Attachment 5: Pre-DA and Design Review Panel Response

Pre-DA and Design Review Panel Comments and Response

Typical Section

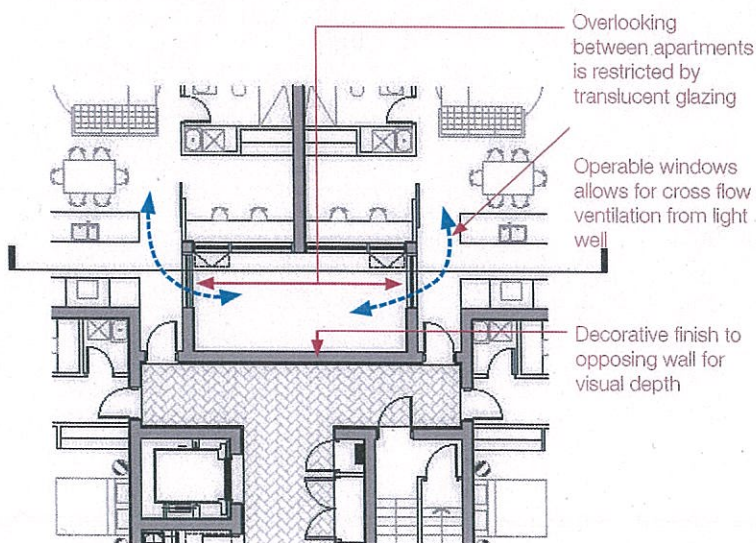
Issue/Comment	Response
8 Lightwells The proposal includes lightwells to Buildings A, B and C. These were not part of the Concept Approval design. The Applicant indicated that these lightwells provide cross ventilation to the associated apartments and that these apartments are included in the total count of cross-ventilated units for the development. The lightwells are approximately 2.5m wide and on Site Section - 02 appear to extend down into the basement parking. The Panel questions the efficacy of the lightwells for cross-ventilation and views them as unacceptable because of the potential for noise and odours to travel between units. They are up to five (5) times taller than they are wide, and would therefore offer little daylight to adjoining spaces, particularly on the lower levels. If the lightwells were removed, along with the adjoining internal rooms (refer below), the overall width of the buildings could be reduced to a footprint similar to that of Building D, thereby increasing the width of the external spaces between the buildings.	Attached is a section which indicates the workings and benefits of the lightwells. We note that these do not extend down into the basement parking area but only to the ground level at which there is landscaping. We believe that the lightwells are appropriate for the following reasons; • They allow for cross flow ventilation to an additional 50 apartments. • There is no overlooking into other apartments. This has been achieved by directing the windows in particular orientations and providing for translucent glazing where necessary. • They provide visual depth to the study areas. It is noted that a feature wall will be provided to the southern side of the lightwells. • They provide natural light to the study areas. • They provide some natural light to the kitchen area. • They do not have any mechanical discharge into these areas – i.e. there will be no odours.

Light wells are of benefit to the apartment design as they greatly contribute to the amenity of the apartment. This is achieved by allowing the occupant to have access to cross-flow ventilation and allowing the occupant to take advantage of the 'Stack Effect' to aid in passively heating and cooling the apartment. Further benefits include; additional visual depth to the study areas by using a decorative finish to the opposing wall and the opportunity for additional diffuse light to enter the apartment.

- Operable windows to each apartment corridor allow for air to circulate through from the light well and cross ventilate the apartment
- The window to each apartment corridor is translucent and set high off the floor level to maintain privacy
- Windows to the study allow for cross ventilation through each apartment
- During the night cold air sinks into the light well, trapping cool air to help cool the apartment during the summer months
- Warm air purged from the apartment, rises up and out of the Light well during the summer months to help reduce heat load
- Planting to the ground floor, viewed from the lobby adds visual amenity to each lobby. Adding planting also helps to mitigate noise within the light well
- The study area adjacent the operable windows, are of low-noise generation uses.
- Visual depth is created from the study area by using a decorative finish to the opposing wall
